MAVERIK, INC. STORE #250

5100 EAST & 2500 NORTH EDEN, UTAH

LANDSCAPE PLAN

L1

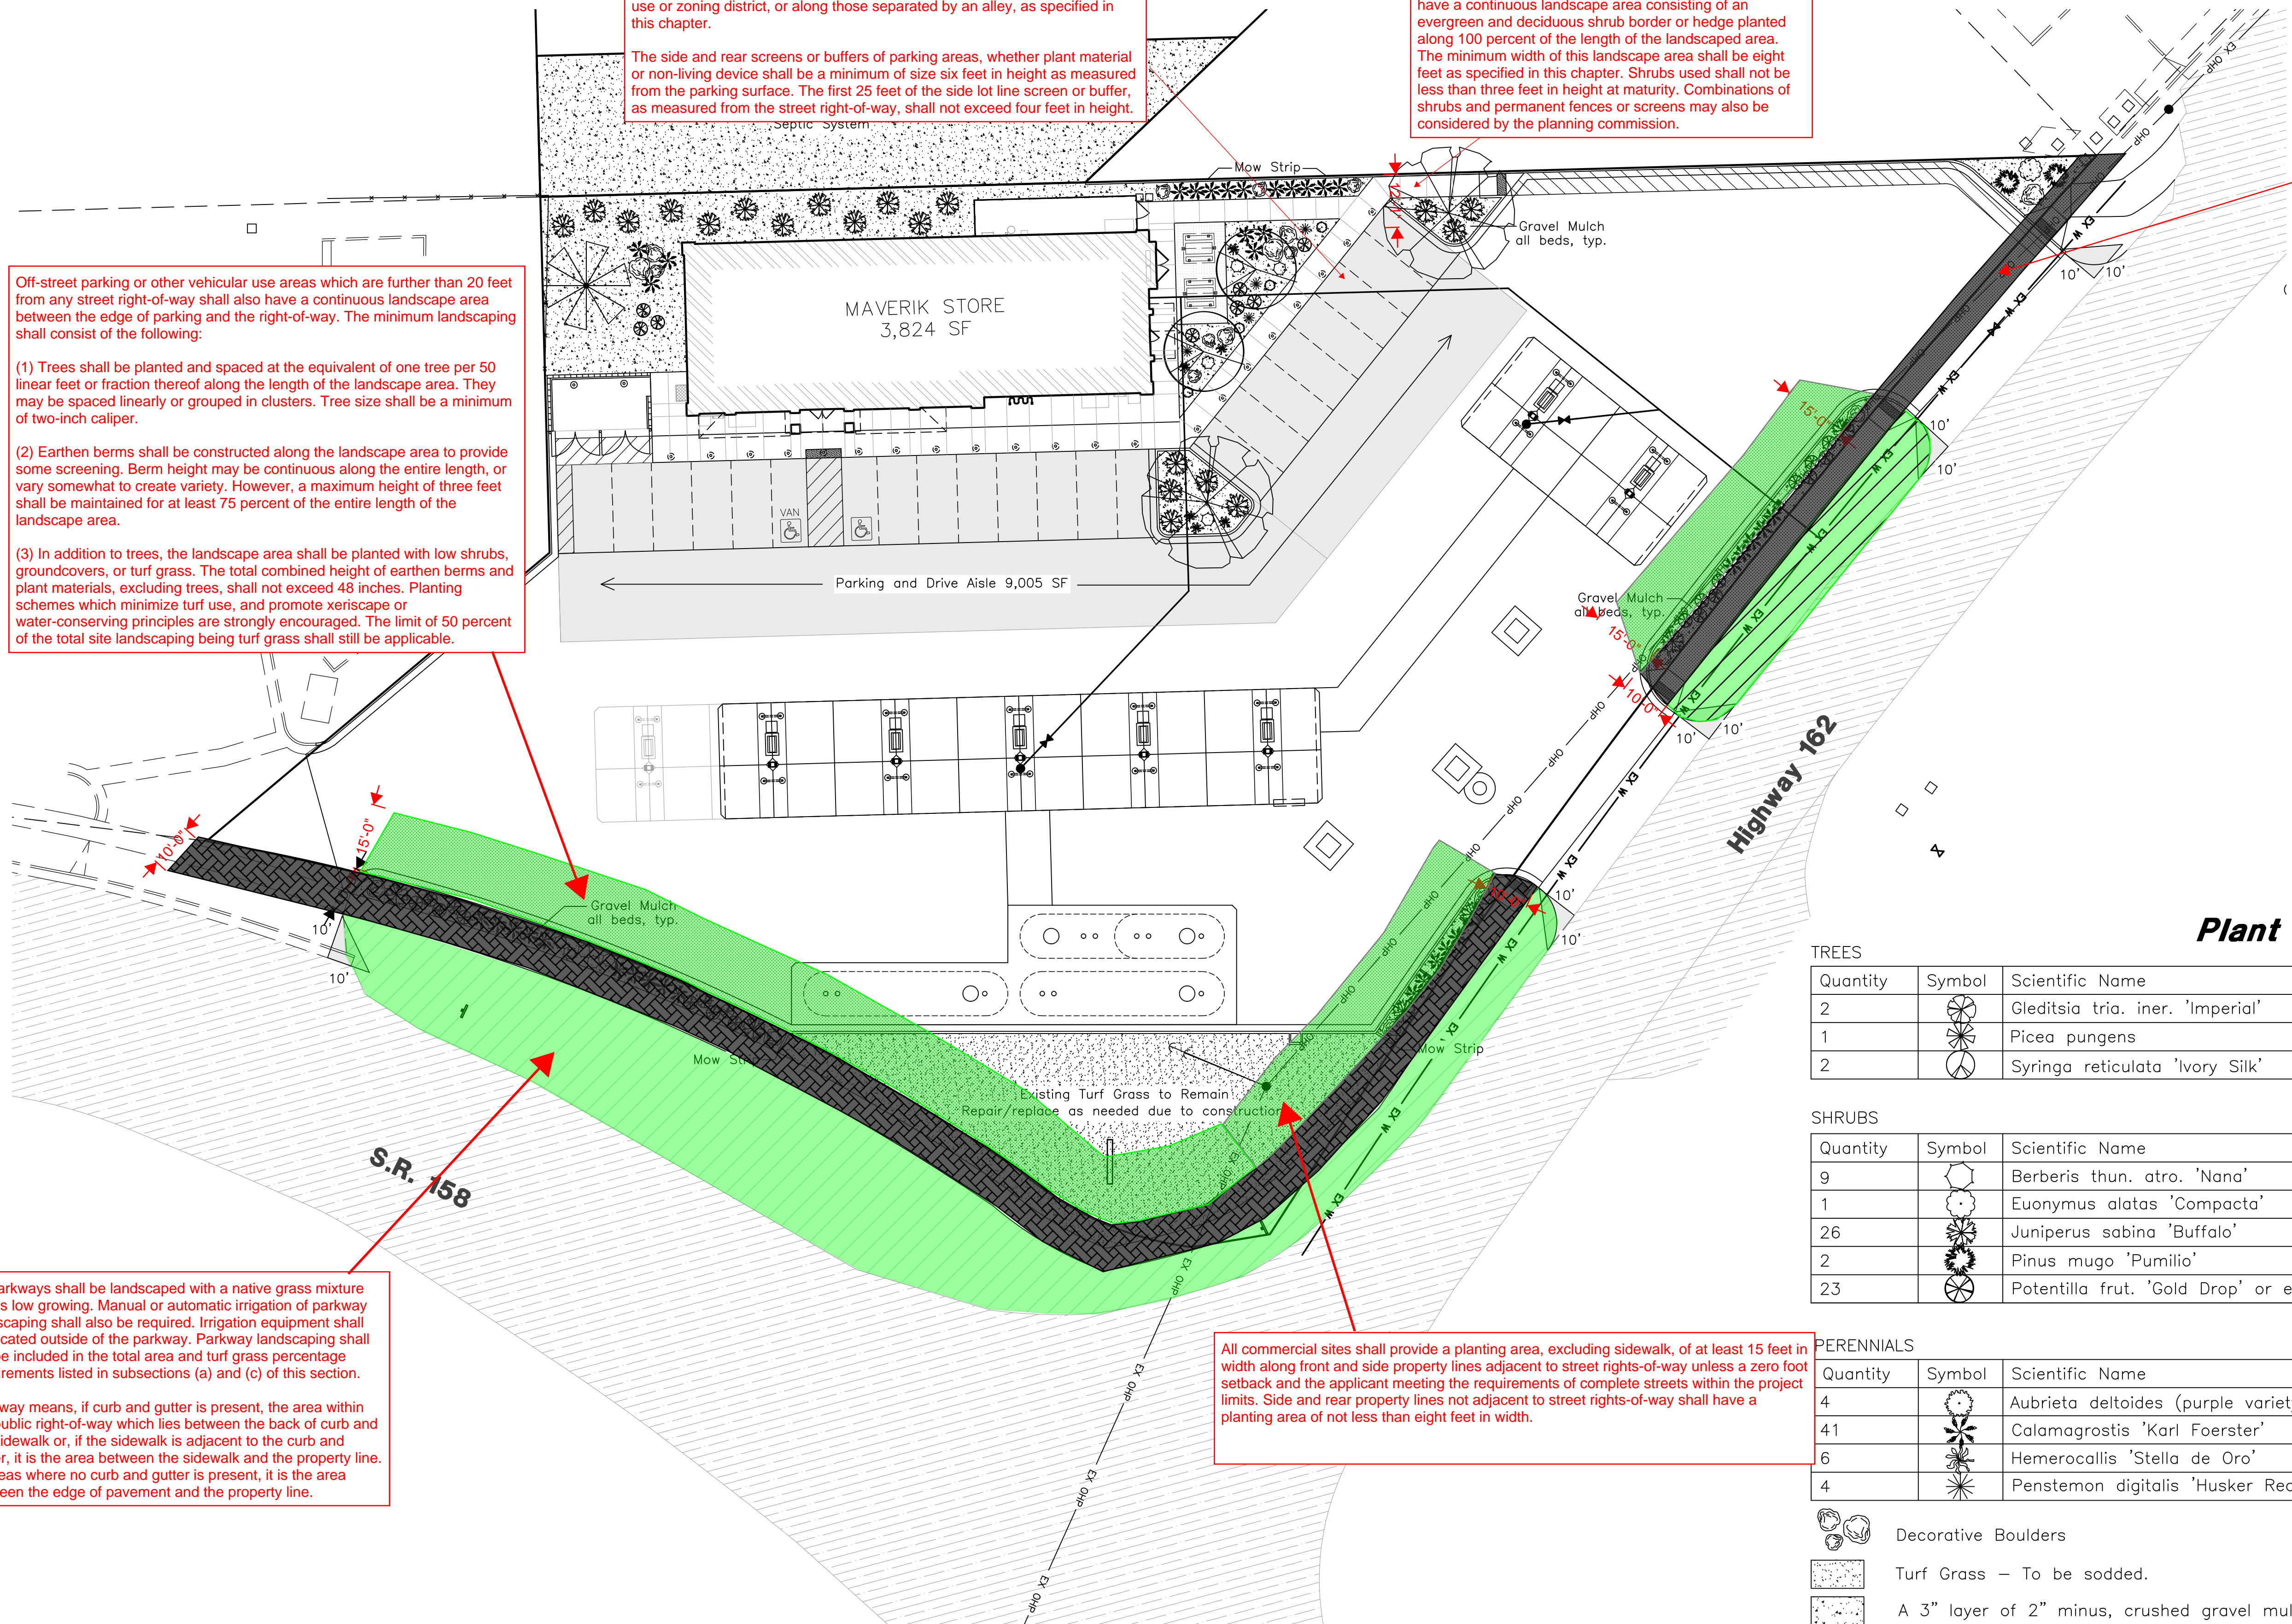
This pathway is planned to be a ten foot bike path. Bike paths shall be paved with asphalt, concrete, or a compacted surface such as roto-mill or crushed rock and shall be separated from roadways by a minimum ten-foot barrier, open space or landscaping. Certain trails may be designated as unpaved trails with the agreement/expectation that they will later be converted to bike paths as funds become available. Bike paths shall be a minimum ten feet in width and designed to AASHTO (American Association of State Highway Transportation Officials) standards for shared use paths, as shown in figure 2.

When an access way intersects with a public right-of-way, or when the subject property abuts the intersection of two or more public rights-of-way, all landscaping and screening within the triangular areas described below shall provide unobstructed cross-visibility at a level between two and eight feet in height. Trees may be planted inside the triangular areas, but shall be trimmed such that no limbs or foliage extend into the cross-visibility zone, and placed so as not to create a traffic hazard. Plant materials, excepting turf grass, shall not be located closer than three feet from the edge of any access way pavement. The triangular areas referred to above are defined as follows:

(1) The area of property on either side of an access way formed by the intersection of each side of the access way and the public right-of-way line. The two sides of the triangle shall be ten feet in length measured from the point of intersection and the third side (hypotenuse) being a line connecting the ends of these two sides. (2) The area of property located at a corner formed by the intersection of two or more public rights-of-way. The two sides of the triangle shall be formed by the street rights-of-way lines for a length of 40 feet back from their intersection and the third side being a line connecting the ends of these two sides.

Parking areas shall be screened or buffered from view along all street rights-of-way or along any property line, which is contiguous to a residential use or zoning district, or along those separated by an alley, as specified in this chapter.
The side and rear screens or buffers of parking areas, whether plant material or non-living device shall be a minimum of size six feet in height as measured from the parking surface. The first 25 feet of the side lot line screen or buffer, as measured from the street right-of-way, shall not exceed four feet in height.

Parking areas within 12 feet of a side or rear lot line shall have a continuous landscape area consisting of an evergreen and deciduous shrub border or hedge planted along 100 percent of the length of the landscaped area. The minimum width of this landscape area shall be eight feet as specified in this chapter. Shrubs used shall not be less than three feet in height at maturity. Combinations of shrubs and permanent fences or screens may also be considered by the planning commission.

Off-street parking or other vehicular use areas which are further than 20 feet from any street right-of-way shall also have a continuous landscape area between the edge of parking and the right-of-way. The minimum landscaping shall consist of the following:

- (1) Trees shall be planted and spaced at the equivalent of one tree per 50 linear feet or fraction thereof along the length of the landscape area. They may be spaced linearly or grouped in clusters. Tree size shall be a minimum of two-inch caliper.

(2) Earthen berms shall be constructed along the landscape area to provide some screening. Berm height may be continuous along the entire length, or vary somewhat to create variety. However, a maximum height of three feet shall be maintained for at least 75 percent of the entire length of the landscape area.

(3) In addition to trees, the landscape area shall be planted with low shrubs, groundcovers, or turf grass. The total combined height of earthen berms and plant materials, excluding trees, shall not exceed 48 inches. Planting schemes which minimize turf use, and promote xeriscape or water-conserving principles are strongly encouraged. The limit of 50 percent of the total site landscaping being turf grass shall still be applicable.

All parkways shall be landscaped with a native grass mixture that is low growing. Manual or automatic irrigation of parkway landscaping shall also be required. Irrigation equipment shall be located outside of the parkway. Parkway landscaping shall not be included in the total area and turf grass percentage requirements listed in subsections (a) and (c) of this section.
Parkway means, if curb and gutter is present, the area within the public right-of-way which lies between the back of curb and the sidewalk or, if the sidewalk is adjacent to the curb and gutter, it is the area between the sidewalk and the property line. In areas where no curb and gutter is present, it is the area between the edge of pavement and the property line.

All commercial sites shall provide a planting area, excluding sidewalk, of at least 15 feet in width along front and side property lines adjacent to street rights-of-way unless a zero foot setback and the applicant meeting the requirements of complete streets within the project limits. Side and rear property lines not adjacent to street rights-of-way shall have a planting area of not less than eight feet in width.

2 D/F ILLUMINATED MONUMENT SIGN  
SCALE: 3/8" = 1'-0"

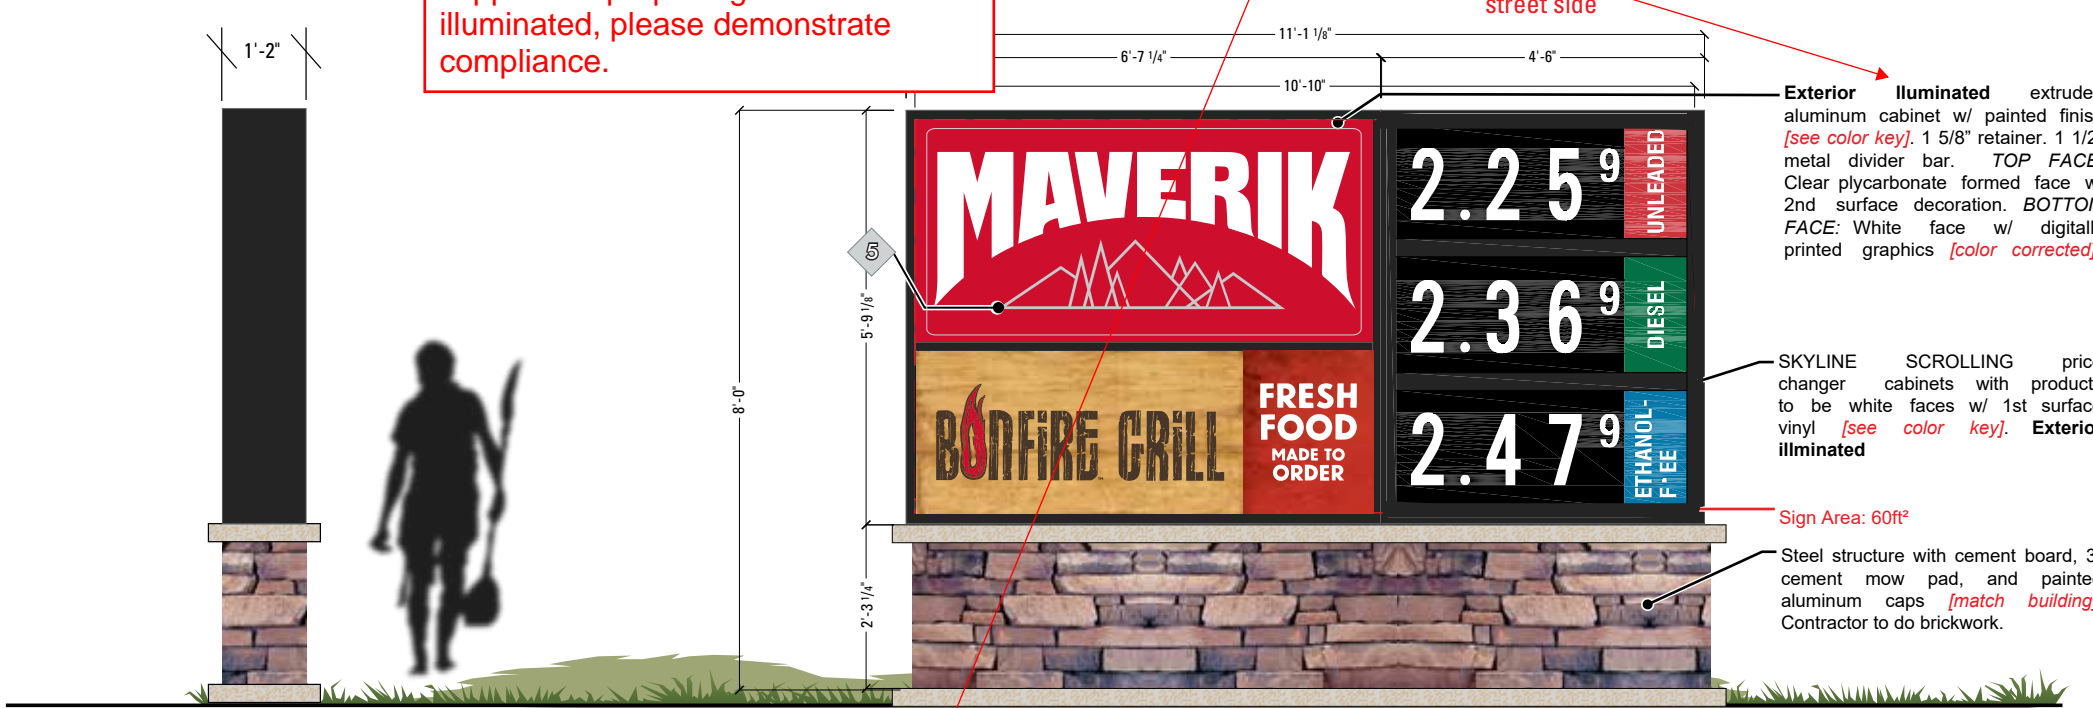
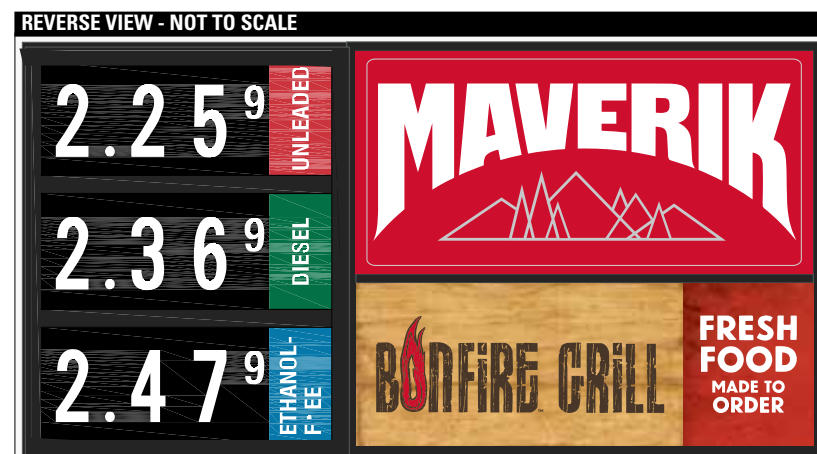
Unless otherwise specified, all exterior lighting of a sign shall be downward directed from the top of the sign, and oriented so as to illuminate only the sign area, as defined in section 101-1-7, excluding the supports. If proposing exterior illuminated, please demonstrate compliance.

No direct artificial light, as defined in section 101-1-7, shall be projected from the sign area or beyond the sign area, including by means of diffusion or refraction through a translucent or transparent surface.

If a downward directed light will be proposed instead, we will need to see illumination details. Exterior lighting of a sign shall not exceed a ratio of 75 lumens per square foot of sign area. This ratio shall be calculated by combining the total lumen output of each artificial light source divided by the square footage of the sign area.

**2** PAN CHANNEL LETTERS  
SCALE: 3/8" = 1'-0"  
48" LETTER SET

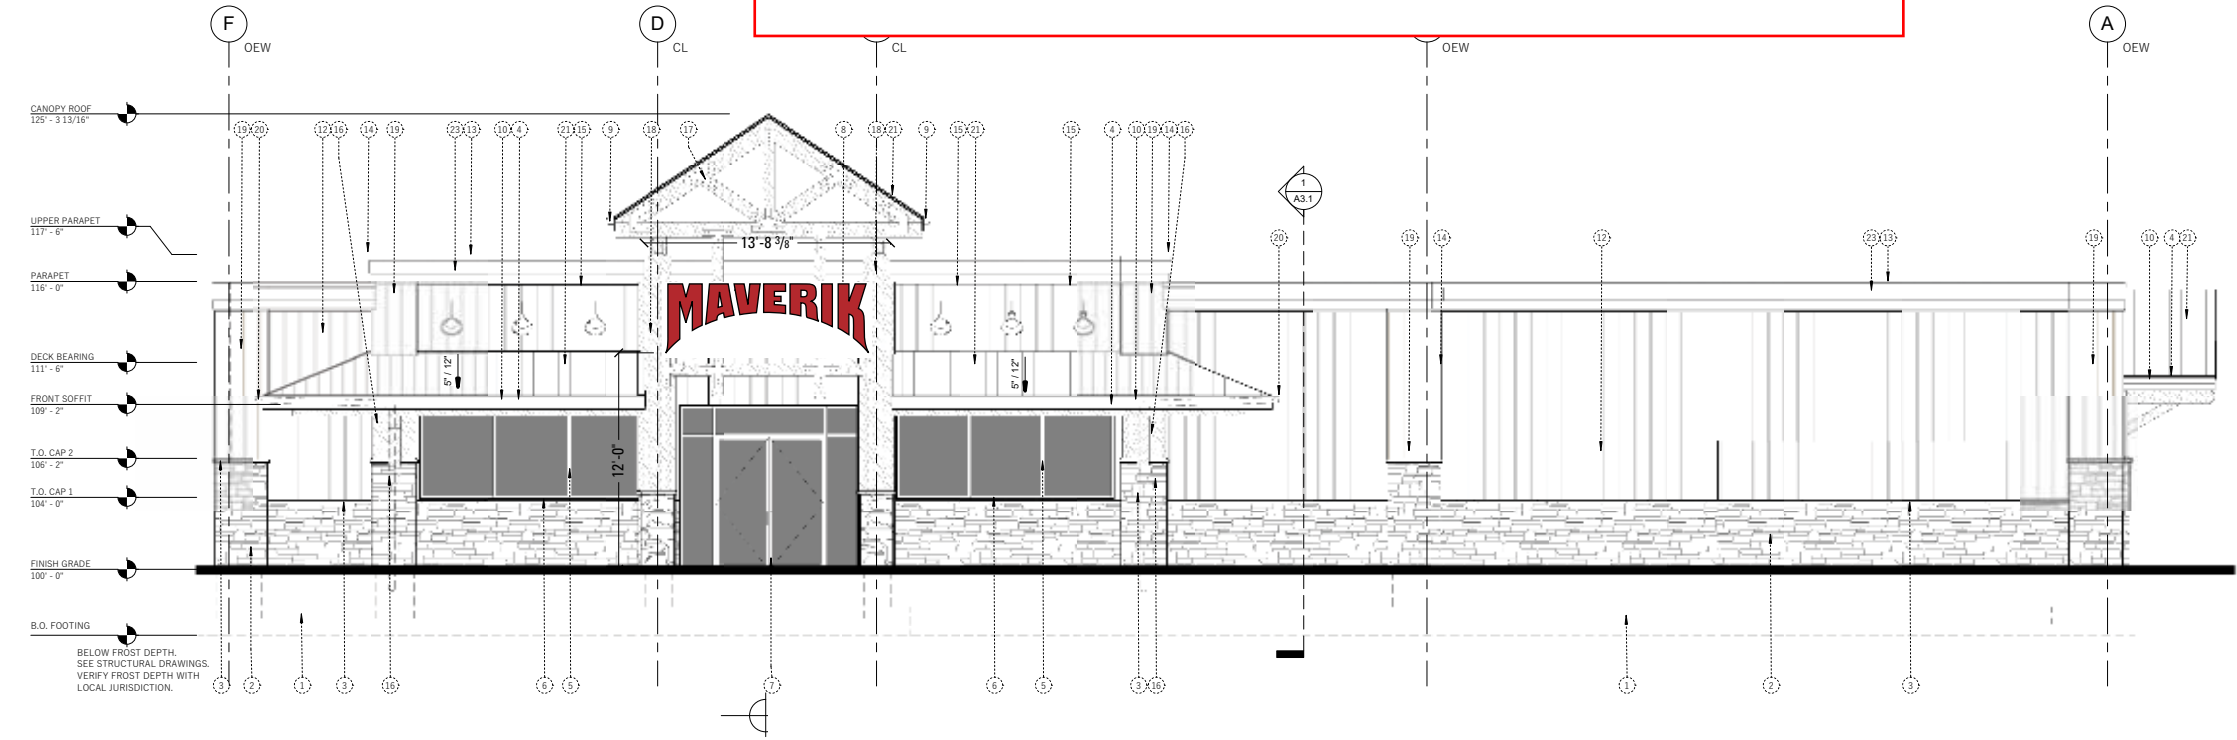
Unless otherwise specified, all exterior lighting of a sign shall be downward directed from the top of the sign, and oriented so as to illuminate only the sign area, as defined in section 101-1-7, excluding the supports. If proposing exterior illuminated, please demonstrate compliance.

This lighting is not permitted. If a downward directed light will be proposed instead, we will need to see illumination details.

Exterior lighting of a sign shall not exceed a ratio of 75 lumens per square foot of sign area. This ratio shall be calculated by combining the total lumen output of each artificial light source divided by the square footage of the sign area.

No direct artificial light, as defined in section 101-1-7, shall be projected from the sign area or beyond the sign area, including by means of diffusion or refraction through a translucent or transparent surface. However, direct artificial light, excluding diffused or refracted light, for a sign area that does not have a frame or separate background, as in the case of a logo or individual lettering mounted to a wall without a defined sign perimeter, may illuminate or reflect onto a background surface, such as a wall, beyond the exterior perimeter of the sign area, provided that: 1. It shall not exceed six inches beyond the sign area; 2. It shall be shielded so as not to project light onto any other surface.
